SUBJECT: Dam Inspection Report for MEMA #105 Silver Lake Dam

#105 Silver Lake Dam
Town of Buckport, Hancock County, ME

Hazard & Condition Report
Date of Inspection – 10/12/2021

RE: Condition Assessment of #105 Silver Lake Dam, Town of Bucksport, Hancock County, ME

6. Stone wave protection (rip-rap) settled by up to 2 feet at the concrete connecting block - arrow. No visible distress in concrete.

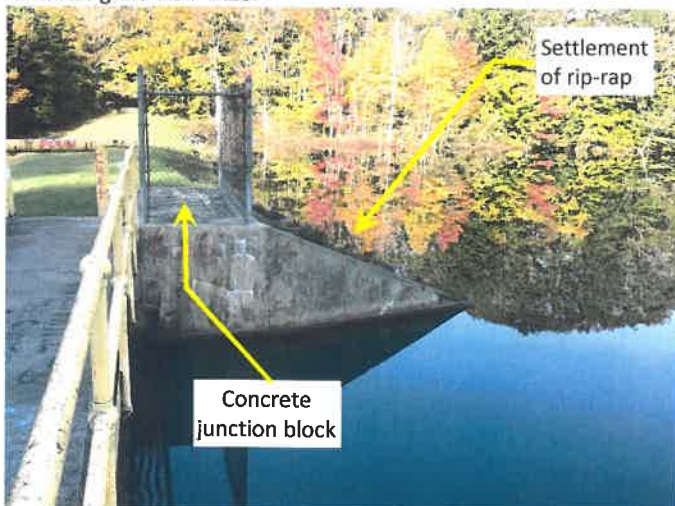
1. Left abutment from top of dam (TOD). Brush recently cut, bank well grassed. Some settlement along TOD. Downstream slope has significant settlement in place.

2. Uneven TOD & stone wave protection. Waters edge not straight indicating settlement and/or riprap slippage. No new shorefront development upstream of dam.

3. Left embankment downstream recently cleared of brush. Both the inclined & level surfaces show unevenness indicating embankment or local slippage.

4. Left embankment looking downstream. The brown area is a muddy seep which must be inspected after spring runoff & around labor day & monitored for flow & reservoir stage.

5. Settlement, random boulders & uneven earthwork surface. Concrete cracked but surfaces are plain. This concrete block is connected to the reinforced concrete cutoff wall.

11. Spillway downstream channel between left & right wingwalls silted. Note flattened grass from recent storm.

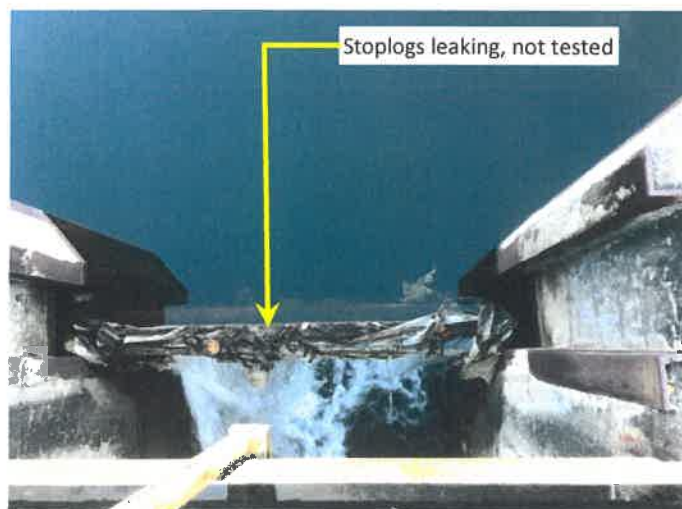
7. Left downstream mass gravity channel. Built 1930, re-faced 1984, with Gunitite. Photos show similar cracks & efflorescence reported by the Army Corps of Engineers (COE) in 1978, A3&A6. Efflorescence shows calcium carbonate developed by evaporation.

8. Same as A7. Craze cracks & a lift joint can be seen. Efflorescence caused by dissolved free lime in the leak dissolved within the mass gravity concrete wall. No inward deflection or iron oxide from rebar seen along the wall - A18.

9. Upstream, left mass-gravity retaining wing wall & footbridge. Minor cracking & efflorescence at junction with block. Note graffiti.

10. Upstream, right mass-gravity retaining wing wall & footbridge.

14. Stoplog gate guides.

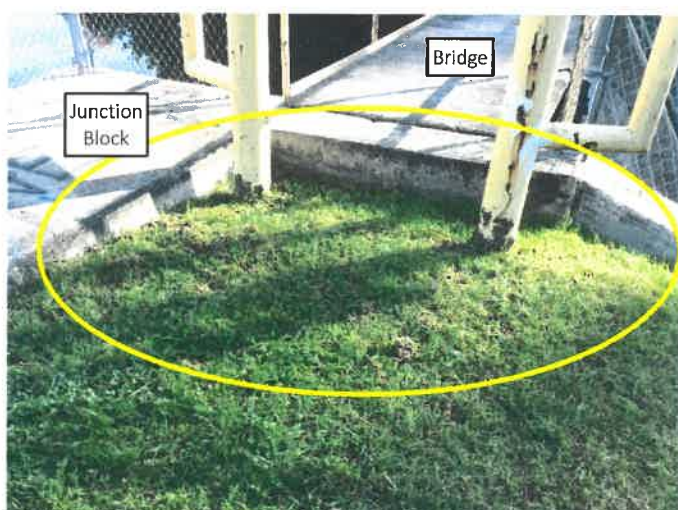
12. Spillway & stoplog weirs. Note the right bulkhead overtopping considerably more than the left & leaking stoplogs leaking. Note difficult access to stoplogs.

13. One 8' X 6' wide stoplog gate.

16. Settlement of right embankment at walkway. No movement seen on the concrete junction block.

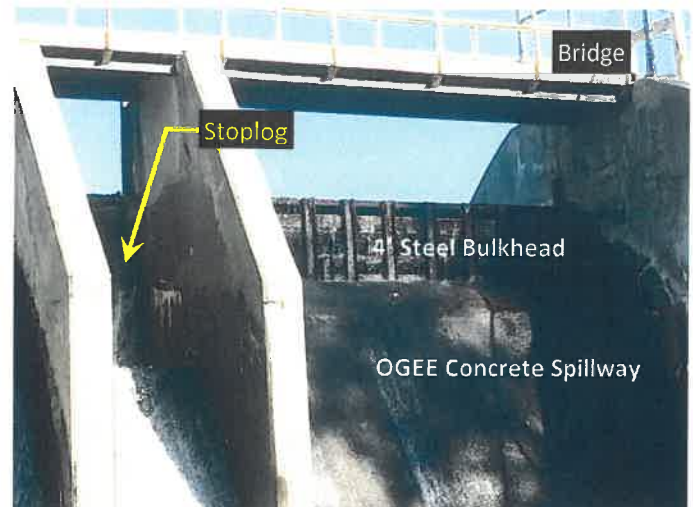
15. Settlement of left embankment at walkway. No defects seen on the concrete junction.

28. Typical low flow marsh showing seepage. This spot is located about 150 feet from the left spillway wall.

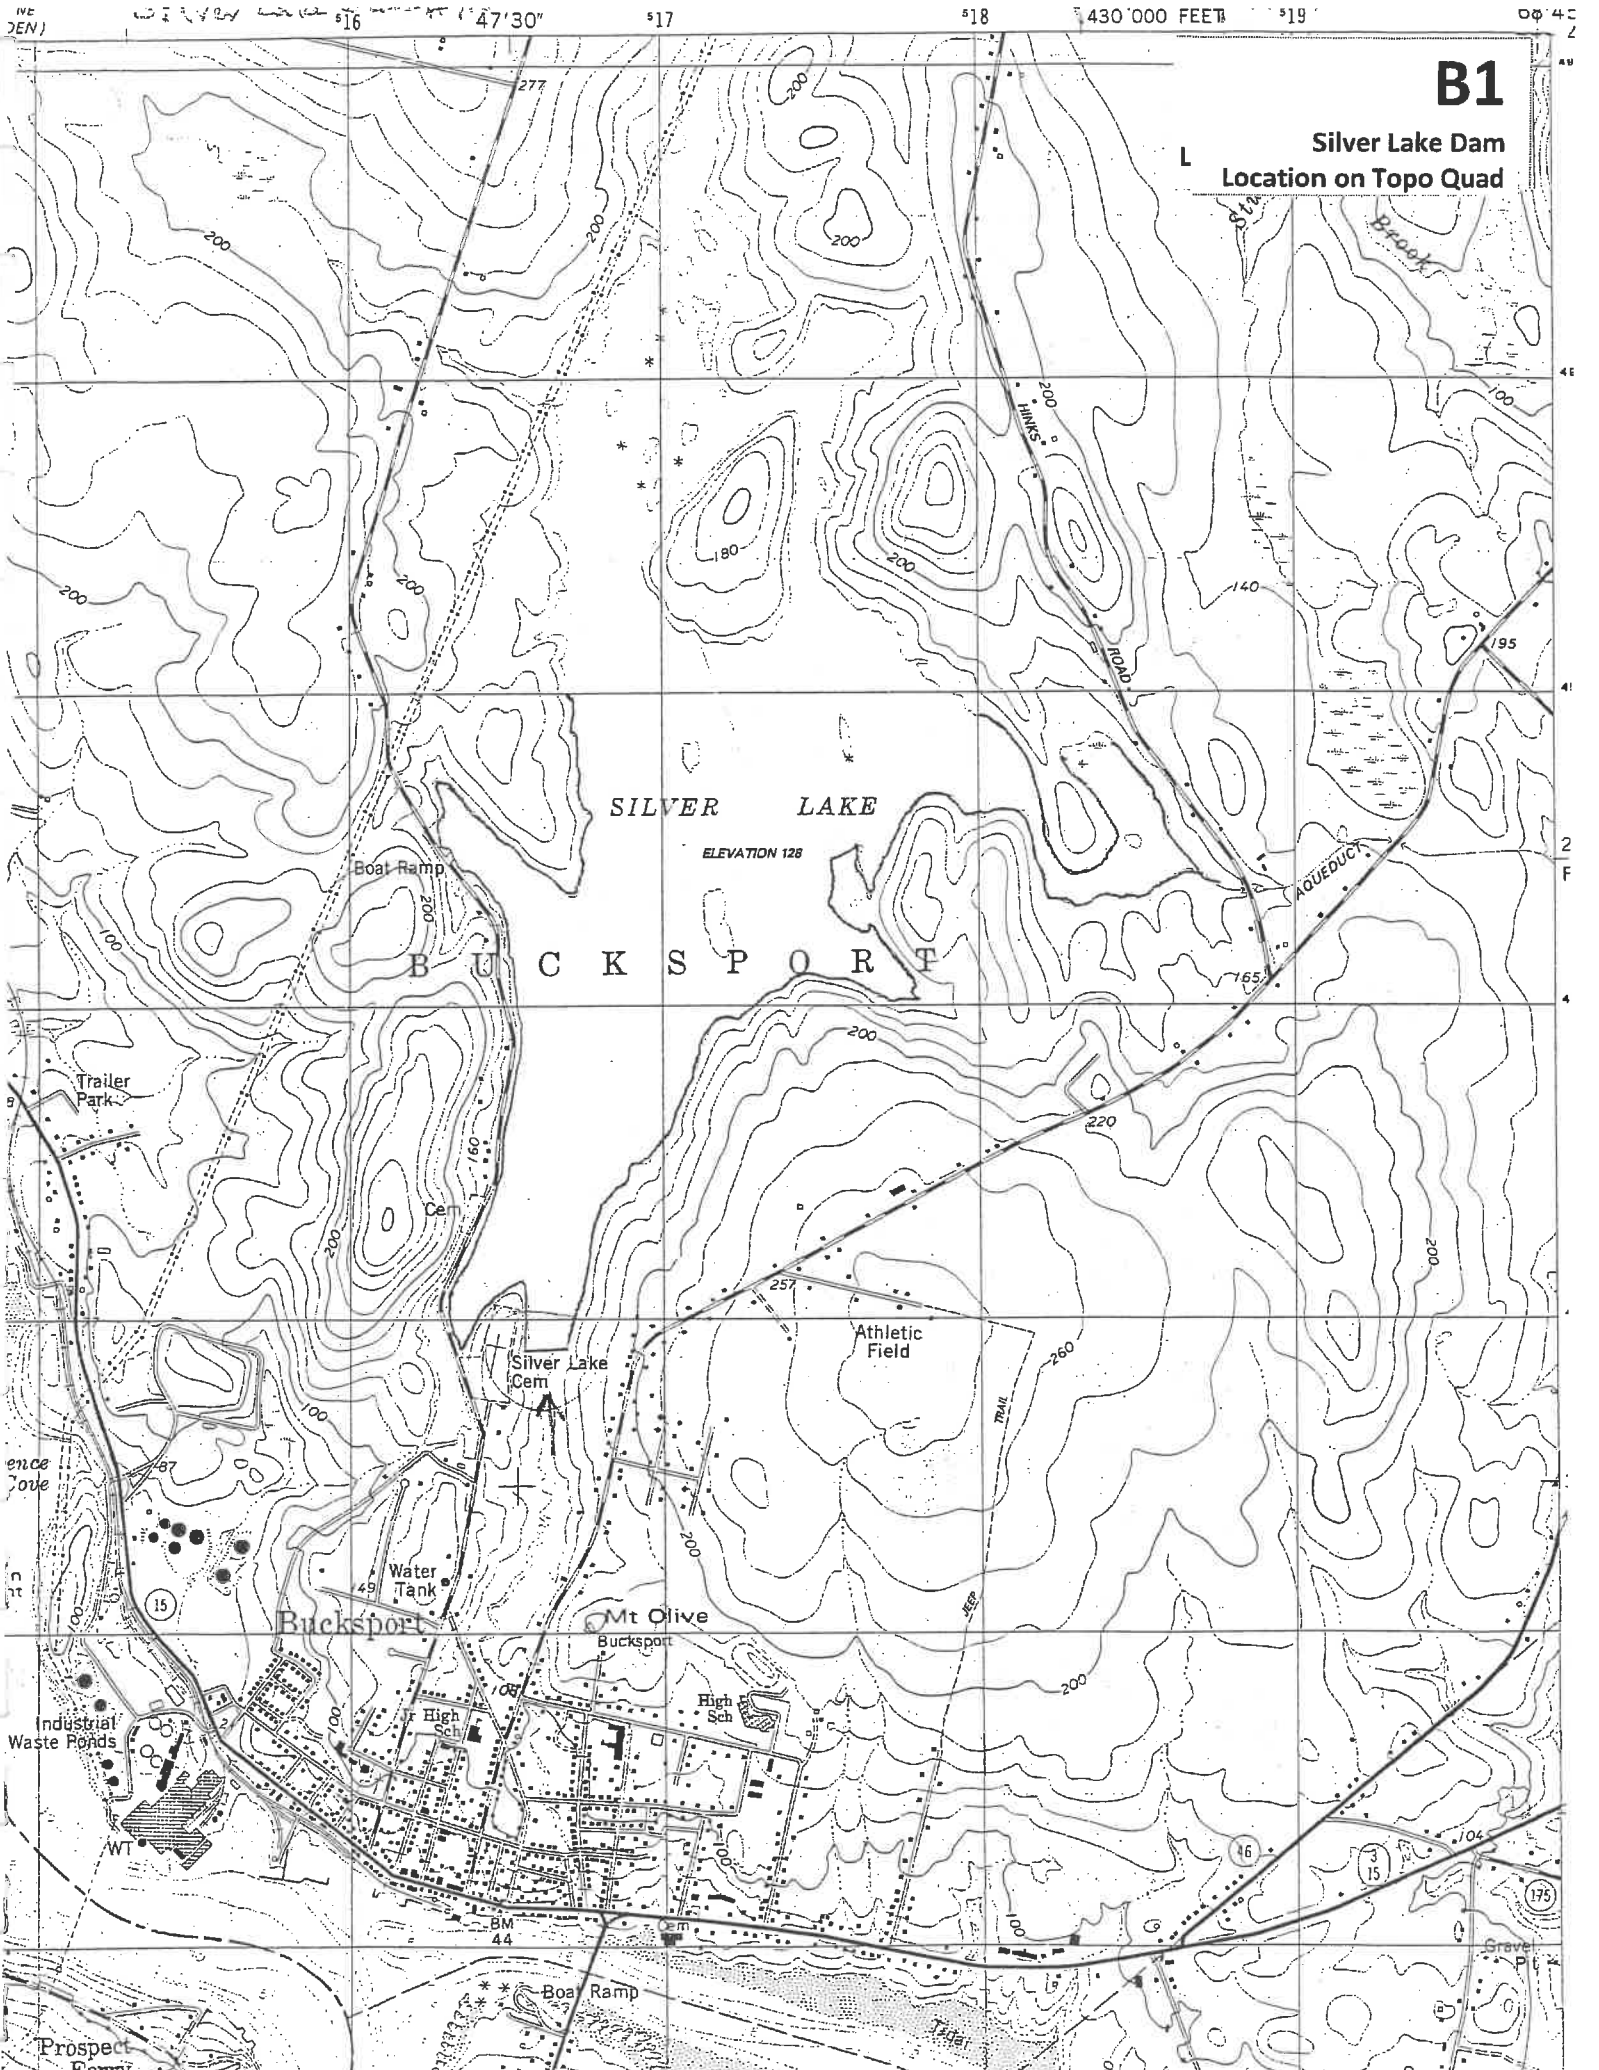
17. Left embankment/wing-wall abutment. Swamp from seepage in the area where the brush has been cut.

18. Right embankment/wing-wall abutment. Note either settlement or erosion along wall

19. Right Spillway. The reason for overflow is that the top of the bulkhead is lower than the left bulkhead.

20. Stoplog Gate & Left Spillway.

21. Spillway Bridge from left embankment.

22. Right embankment stone wave protection (rip-rap). Remove brush & rearrange riprap to correct slope. Place new riprap where embankment is exposed.

23. Top of Right embankment & downstream face — mostly covered by grass. Downstream face of dam uneven due to local settlement and/or small slips.

24. Right embankment plane recently cut & uneven. Soil surface could not be seen, however, sporadic settlement, erosion & cracks seen.

25. Right embankment seepage clear, possibly a toe drain outlet.

26. View down right embankment toe. Yellow ellipse is area where at least 6 separate marshes have formed. No seepage carried silt or was discoloured.

27. View down embankment toward seepage. A28 is in the middle of the photo.

INSPECTION & PHOTOS

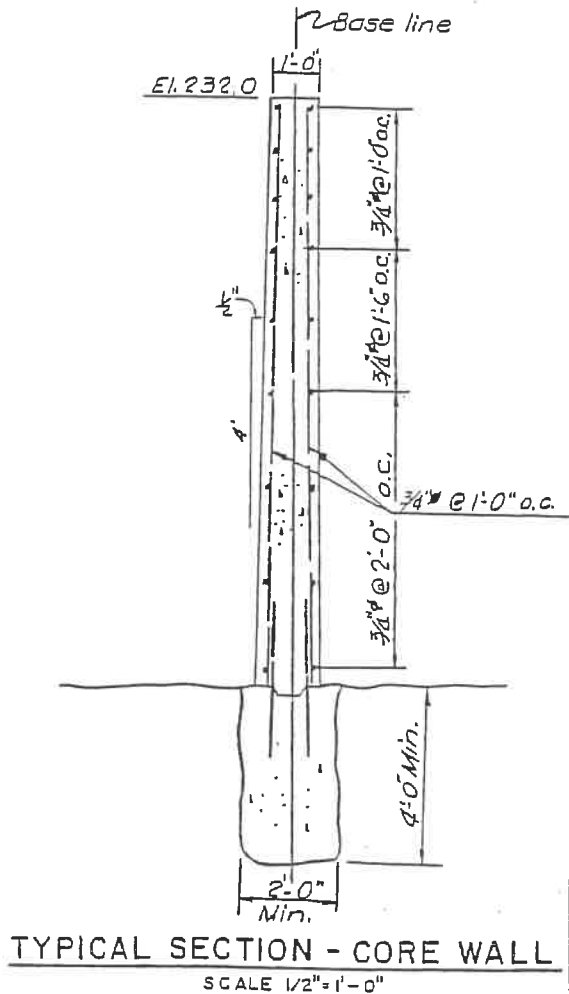
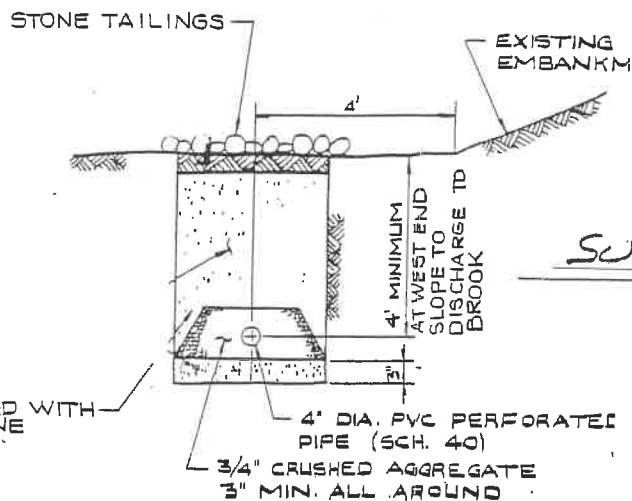
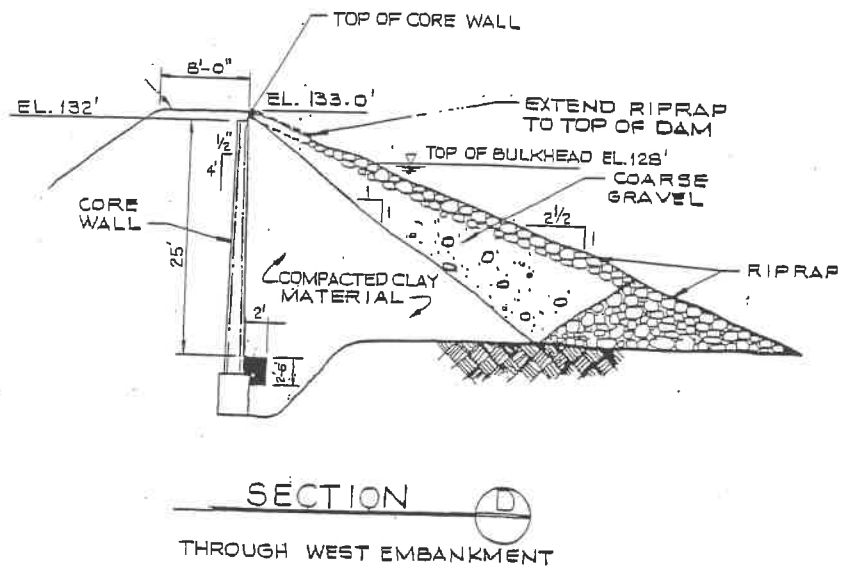
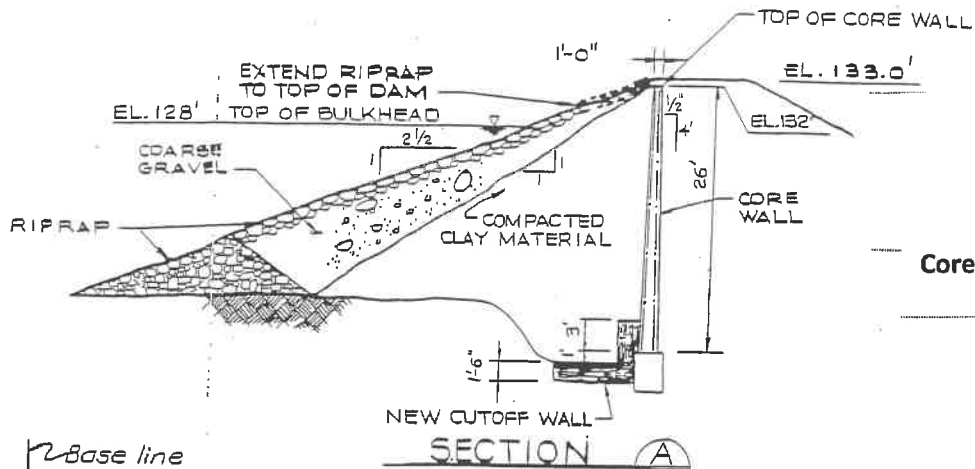
WHAT NEEDS TO BE DETERMINED
IS WHAT % OF SEEPAGE COMES
THROUGH THE DAM

CHECK FOR SEEPAGE
 LIKELY UNDER DRAIN.

UPSTREAM FROM
CHECK DOWNSTREAM FACE OF E
